Glynn Weir Fish Passage Improvement - 9 July 2019

PROPOSED FISH PASSAGE IMPROVEMENTS, GLYNN WEIR, CARDINHAM WATER

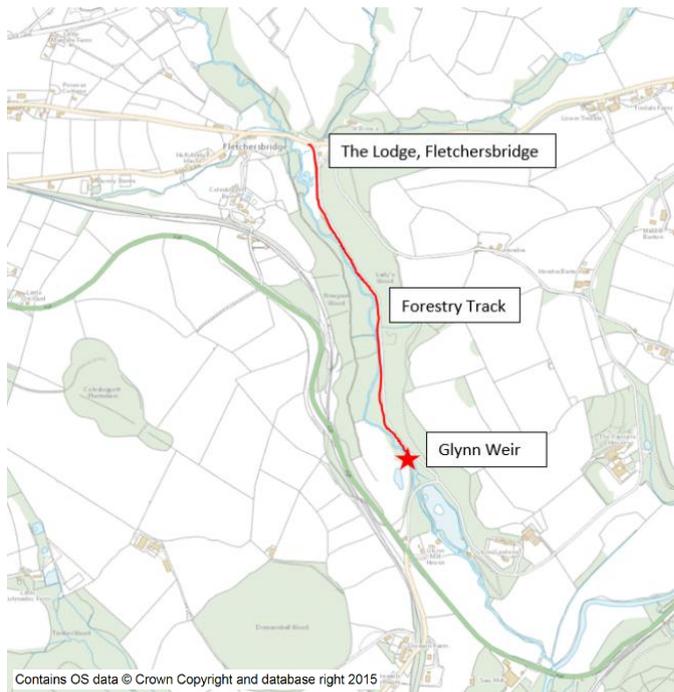
1. The driveway bridge over the Cardinham Water downstream of Glynn Weir is unsuitable for heavy traffic. Fortunately, an alternative route is available from upstream via The Lodge at Fletchersbridge and forestry track. Please see map and photos below. The gateway at Fletchersbridge Lodge indicated below is approximately 4.5m wide.

We envisage lightweight vehicles accessing the site on a daily basis from the downstream access point with plant and materials accessing from Fletchersbridge only when required. This will require liaison with the owner of The Lodge at Fletchersbridge to ensure disruption and damage to gateways and surfaces is kept to the absolute minimum. All surfaces and other physical features must be left in an 'as found condition' as far as practical.
